Lincoln Center Environmental Remediation Trust

Subject: Tentative NPDES Permit No. R5-2011-XXXX, Lincoln Center, Stockton, California

ARCADIS's Comments on the Tentative Waste Discharge Requirements Order for the Lincoln Center Environmental Remediation Trust Groundwater Treatment System, San Joaquin County (Order No. R5-2011-XXXX, NPDES No. CA0084255)

Subject:
Evaluation of 1,1-Dichloroethylene Removal Efficiency for the Lincoln Center
Groundwater Remediation System, Stockton, California

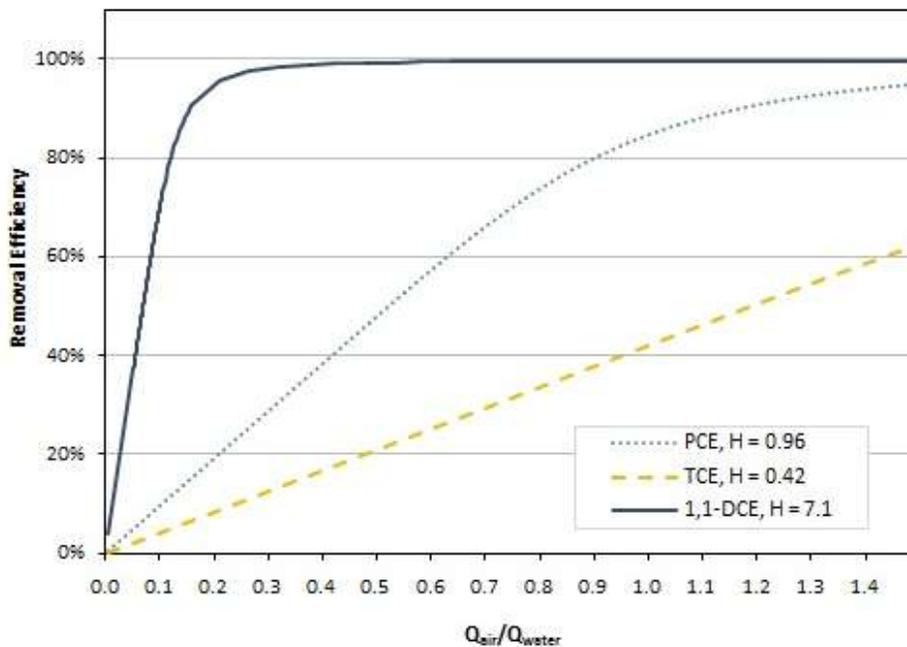
In order to assess the relative strippability of 1,1-DCE, ARCADIS calculated the theoretical removal efficiencies of three constituents (1,1-DCE, PCE, and TCE) via air stripping as a function of the air to water ratio. Model results, presented in Figure 1 (below), indicate that a significantly higher removal efficiency can be achieved for 1,1-DCE at a given air flow rate (i.e., 1,1-DCE has a higher strippability than TCE or PCE due to a higher Henry's law constant).

Based on historical influent and effluent data collected during treatment system monitoring, the existing air stripper removes PCE with approximately 99.6% efficiency. Applying this value to 1,1-DCE, the existing air stripper could theoretically achieve the proposed effluent quality objective of 0.057 µg/L with influent 1,1-DCE concentrations as high as approximately 14.2 µg/L. Note that: (1) the 14.2 µg/L is a conservative estimate as the removal efficiency of 1,1-DCE via air stripping is expected to be greater than 99.6% due to the constituent's higher strippability when compared to PCE; and (2) historically, 1,1-DCE has only been detected sporadically in the influent, and the detected concentrations were significantly lower than the calculated 'theoretical maximum influent' concentration.

Figure 2: Freundlich sorption isotherms. C_e is the solute concentration at equilibrium, and q_e is the sorbed concentration at equilibrium.

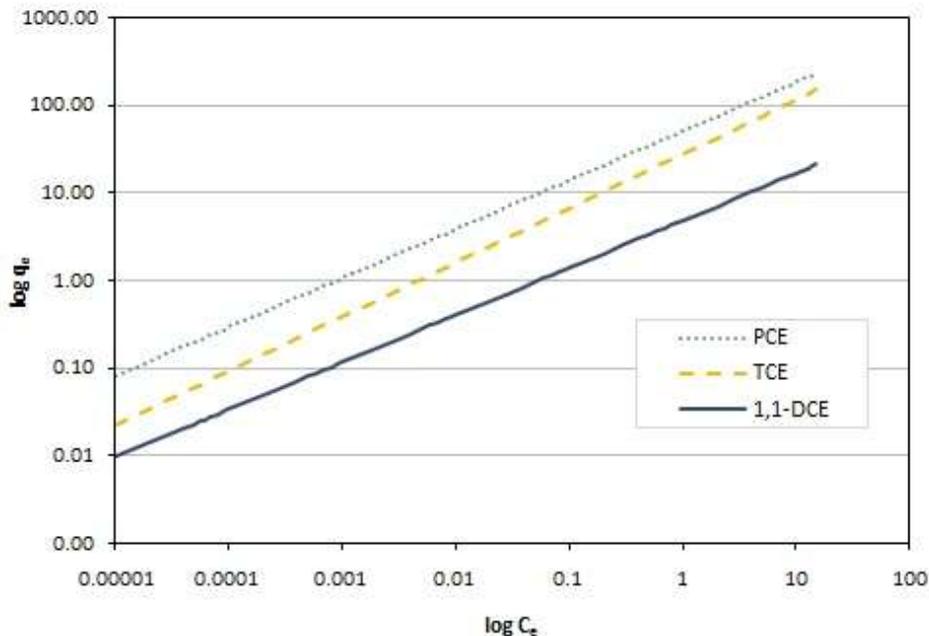
In order to assess the relative adsorbability of 1,1-DCE, ARCADIS plotted Freundlich sorption isotherms for 1,1-DCE, PCE, and TCE (Figure 2). As shown in Figure 2 (below), the sorbed concentration of 1,1-DCE is lower for any given solute concentration (i.e., 1,1-DCE exhibits poor adsorbability in comparison to PCE and TCE).
